# CITY OF PANAMA CITY BEACH

## ADDENDUM NO. 2

### PCB22-86 ITB

### Fire Station No. 31 - Replacement

SHEET NUMBER:  
**E5.1**

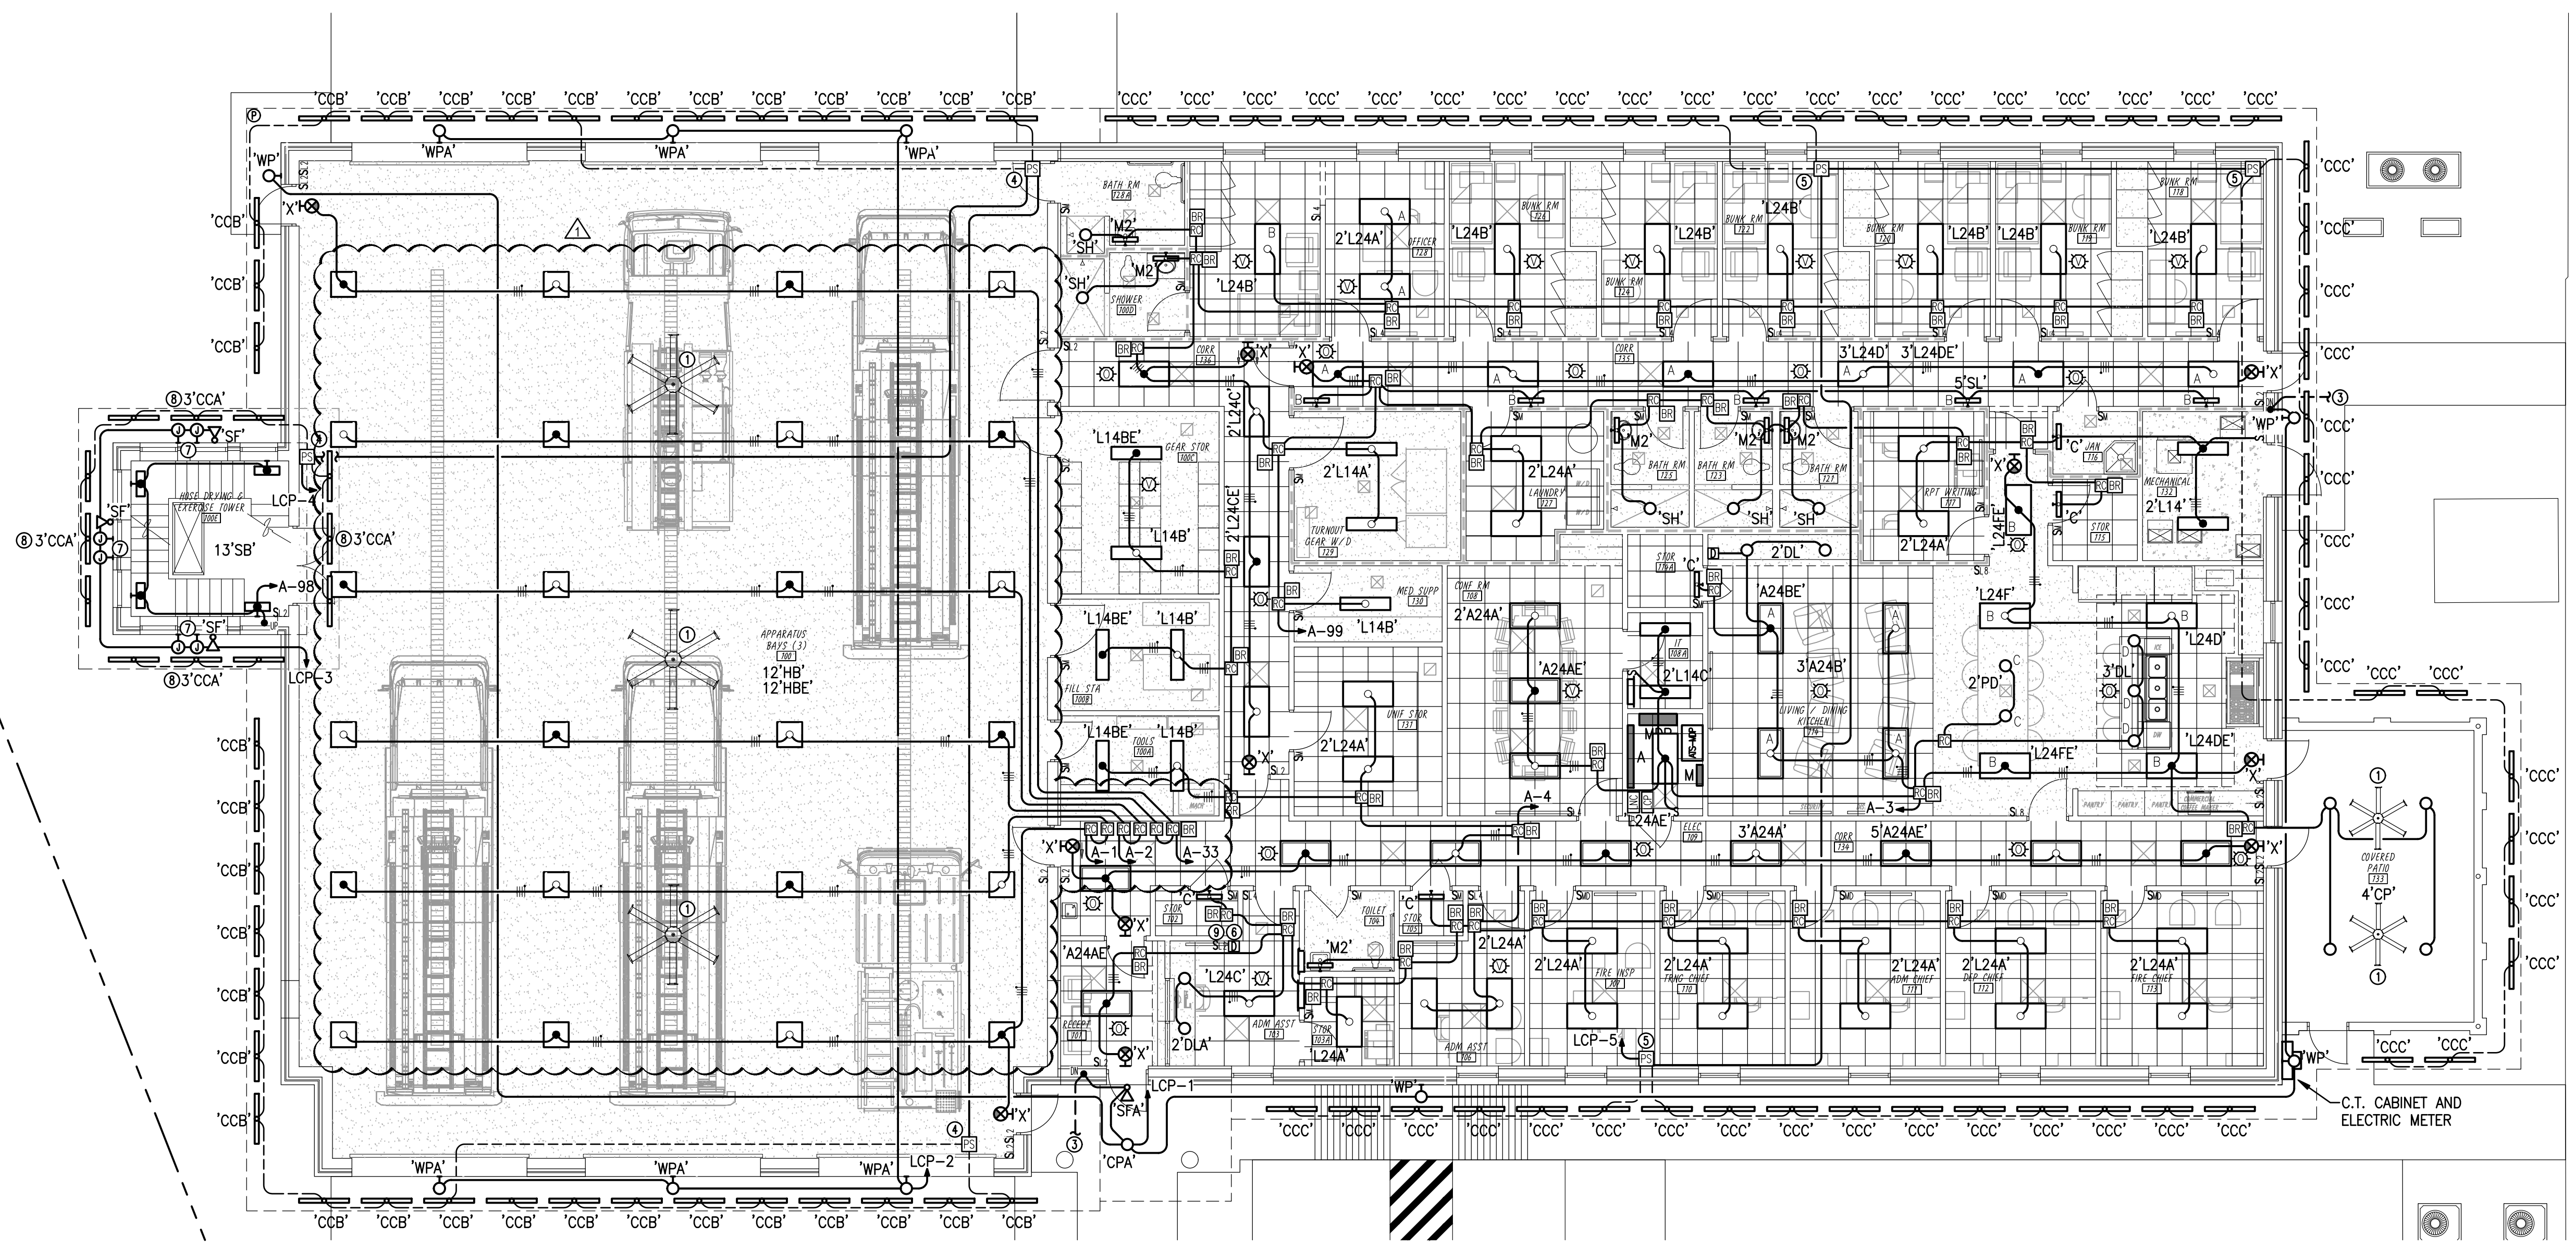
- 7) **Sheets E5.1 - Lighting & E8.2 – Schedules:** Revisions to add three additional room controllers and one additional circuit in Apparatus Bay 100:

Replace Sheet E5.1 in its entirety with new sheet E5.1, Revision 1 dated 10/05/22 (Attachment #1)
